Addendum No.2
to
CONSTRUCTION DOCUMENTS
for

June 2, 2025
2023159.00

NCISD New District Administration Building
21330 Valley Ranch Parkway
New Caney, TX. 77357
June 2, 2025

AS-001

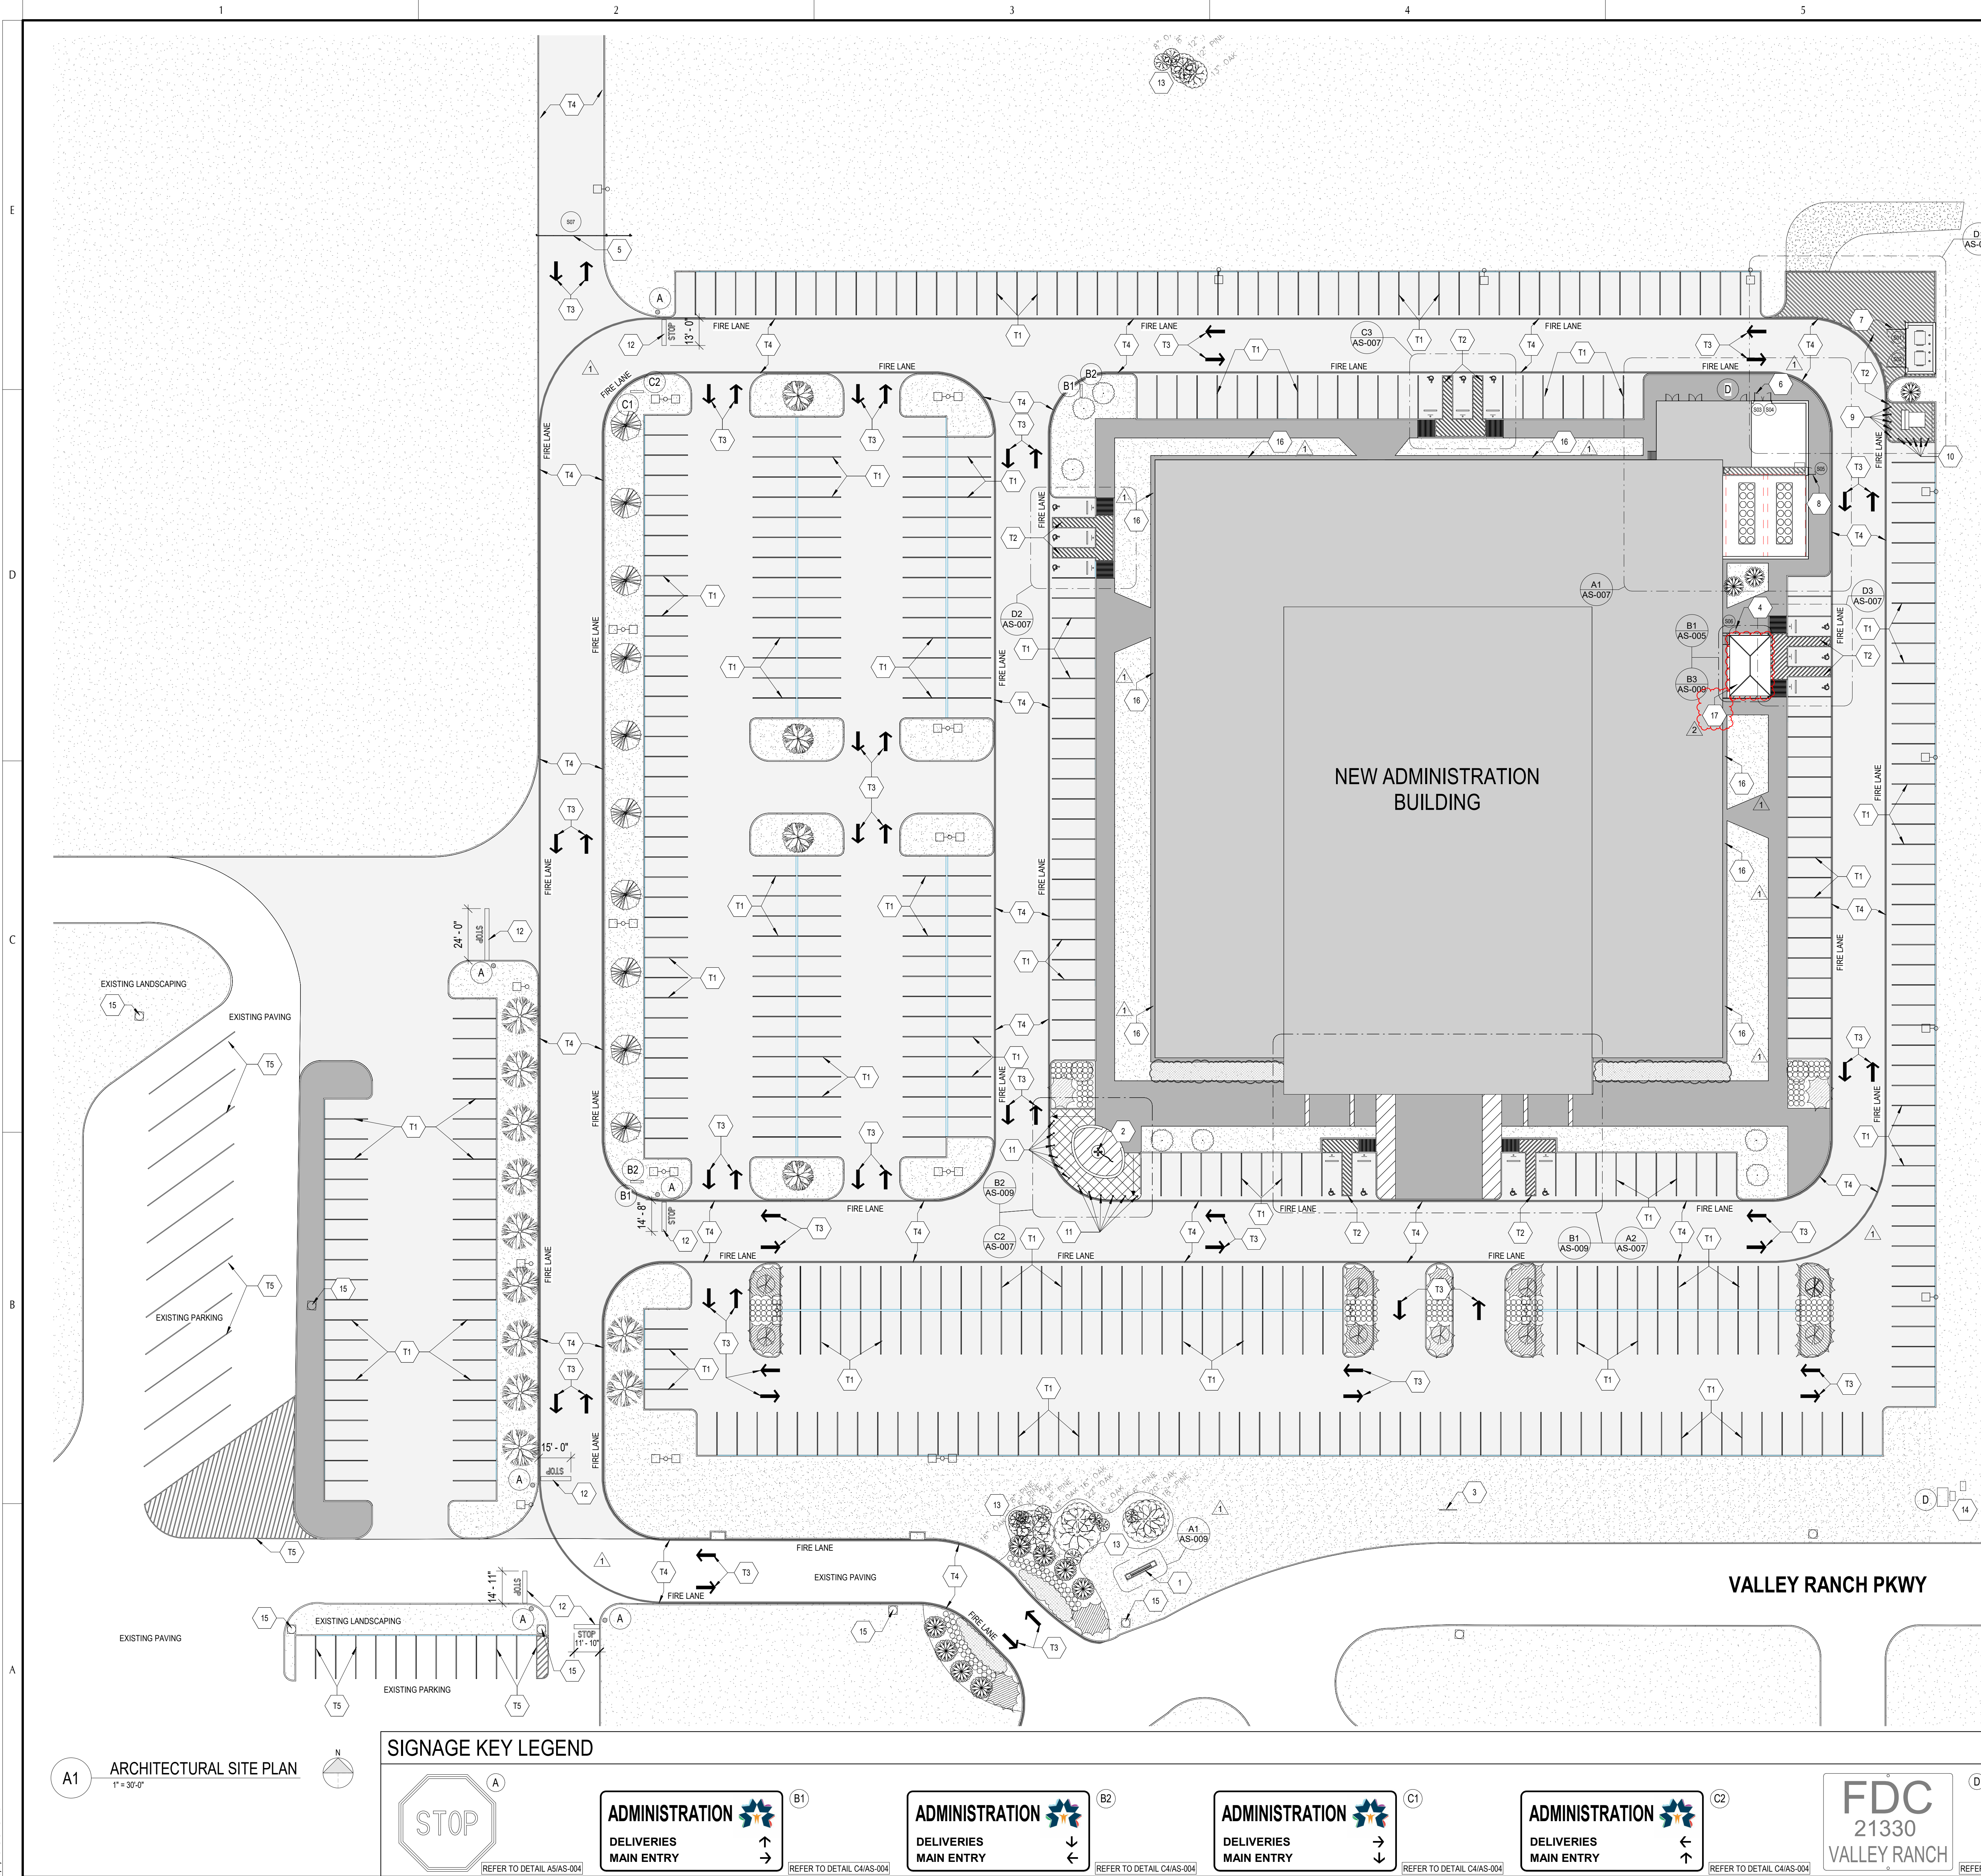
1. Sheet AS-001 – Architectural Composite Plan
 - a. Refer to revised detail B2/AS-001.
2. Sheet AS-002 - Architectural Site Plan
 - a. Sunshade added to plan with keynote 17.

AS-009

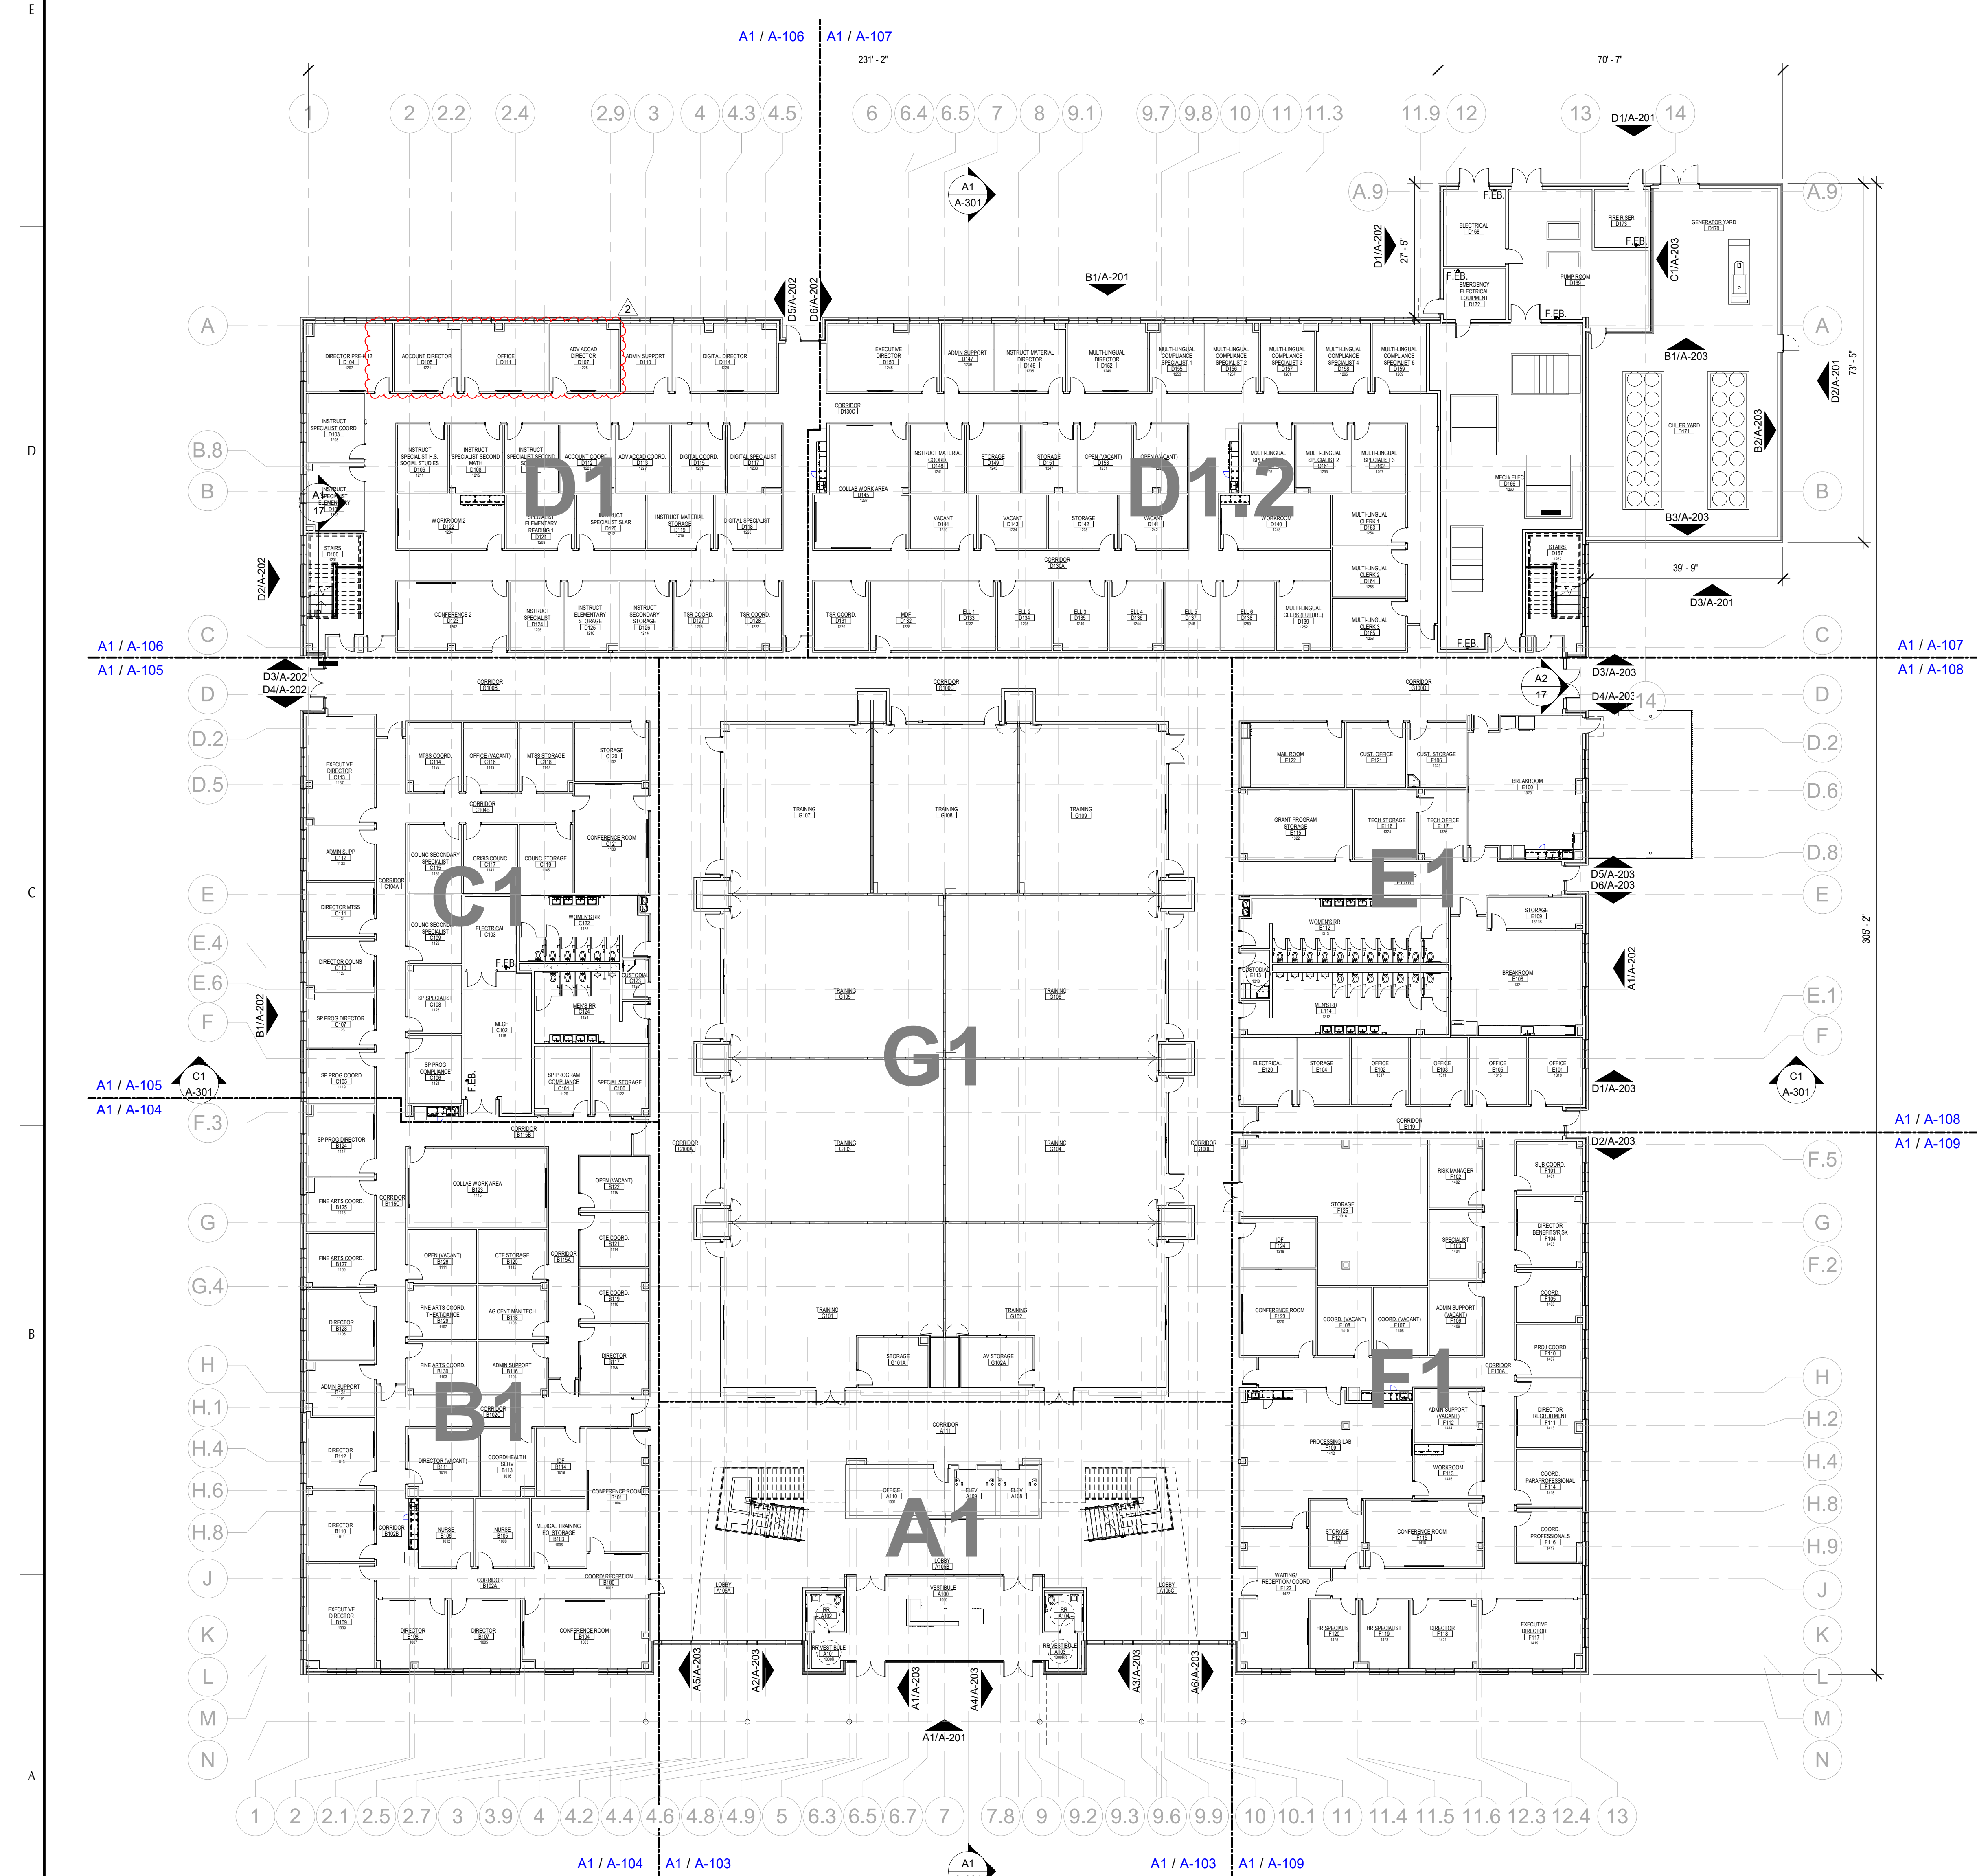
4. Sheet AS-009 - Enlarged Plans and Details
 - a. Elevations C2 and C3 added to show dimensions and callouts for sunshade.
 - b. Detail B3 updated to show sunshade overhead.
